LICENSEE: Indiana Michigan Power Company
FACILITY: Donald C. Cook Nuclear Plant, Units 1 and 2
SUBJECT: SUMMARY OF TELEPHONE CONFERENCE HELD ON JULY 8, 2004,
BETWEEN THE U.S. NUCLEAR REGULATORY COMMISSION (NRC) AND
INDIANA MICHIGAN POWER COMPANY (I&M) REPRESENTATIVES
CONCERNING REQUESTS FOR ADDITIONAL INFORMATION ON DONALD
C. COOK NUCLEAR PLANT, UNITS 1 AND 2, LICENSE RENEWAL
APPLICATION (TAC NOS. MC1202 AND MC1203)

**REQUESTS FOR ADDITIONAL INFORMATION (RAIs) DISCUSSED FOR
DONALD C. COOK (CNP), UNITS 1 AND 2, LICENSE RENEWAL
DURING JULY 8, 2004 TELEPHONE CONFERENCE**

Figure 1—CNP Containment Sectional Elevation (UFSAR Figure 5.2.2-3)

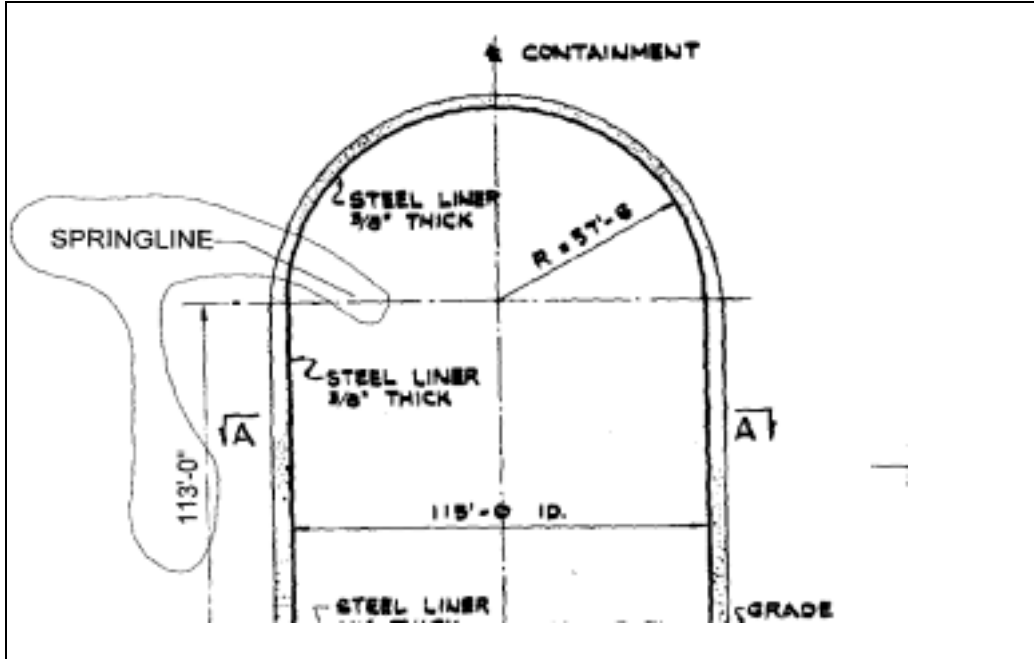
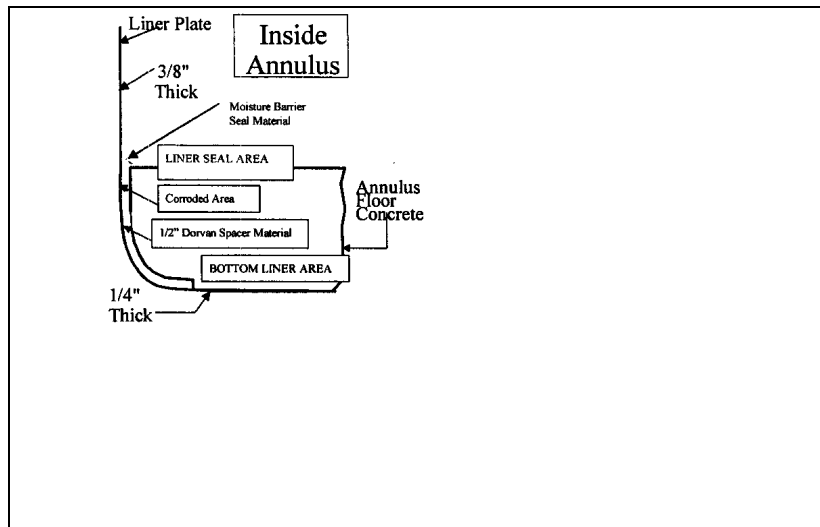
Section 4.6.1 of the LRA discusses the evaluation of the containment liner. The LRA indicates that the liner was evaluated in 1999 after the discovery of localized thinning of the liner. Indicate the amount and extent of the localized liner thinning. Describe how the fatigue evaluation of the locally thinned area was performed.

Status: The fatigue evaluation of the corroded liner does not appear to consider reduced wall thickness due to corrosion. In addition, NRC needs to understand the reference to the SNL report regarding the investigation of a 1/16-inch thick steel plate that contains pitting and corrosion. The staff is looking for additional quantitative data versus qualitative data presented in the RAI response. I&M indicated that they would provide a supplemental response.

The containment structure, as shown in Figure 1 below, consists of side walls measuring 113 feet (nominal) in height from the liner on the base to the spring line of the dome and has a nominal inside diameter of 115 feet. The thickness of the cylinder is 3 feet - 6 inches and the thickness of the dome is 3 feet - 6 inches at the spring line tapering uniformly to 2 feet - 6 inches at the peak of the dome. The base mat consists of a 10-foot thick structural concrete slab, increasing to 20 feet adjacent to the recirculation sump area. The base mat is covered by a ¼-inch nominal thickness carbon steel plate.

A 24-inch thick annulus floor, which is approximately 13 feet wide and extends from the outside of the crane wall to the inside of the vertical containment liner, sits on top of the base mat liner plate (see Figure 2 below). The annulus floor extends around the circumference of the containment, except for 16 feet where a concrete wall exists. A gap between the vertical wall liner and the annulus floor slab was provided to allow for differential expansion. The gap is filled with a ½-inch thick crushable spacer material (Dorvon FR100, closed cell polystyrene similar to Styrofoam®). To protect the bottom liner area (shown in Figure 2) from moisture intrusion, a sealant was applied on top of the Dorvon at the annulus floor grade level between the steel containment liner and the concrete annulus floor.

In May 1997, during an inspection of the Unit 2 liner plate with particular attention to the liner seal area (see Figure 2), degraded and missing sealant material were noted. Minor degraded coatings were noted above the sealant, but no corrosion of the liner was observed. During the sealant repair activity in 1999, corrosion/pitting were noted behind the sealant material. A CR

The only area of significant material loss was at the liner seal area (Figure 2). The affected areas were recoated and resealed, and no further measurable corrosion is expected. Plant procedures were modified to preclude conditions that could compromise seal integrity. The liner seal area has been added to the ASME Section XI, Subsection IWE, and the ASME Section XI, Subsection IWL, Inservice Inspection Programs to assure continued monitoring of this area of degradation.
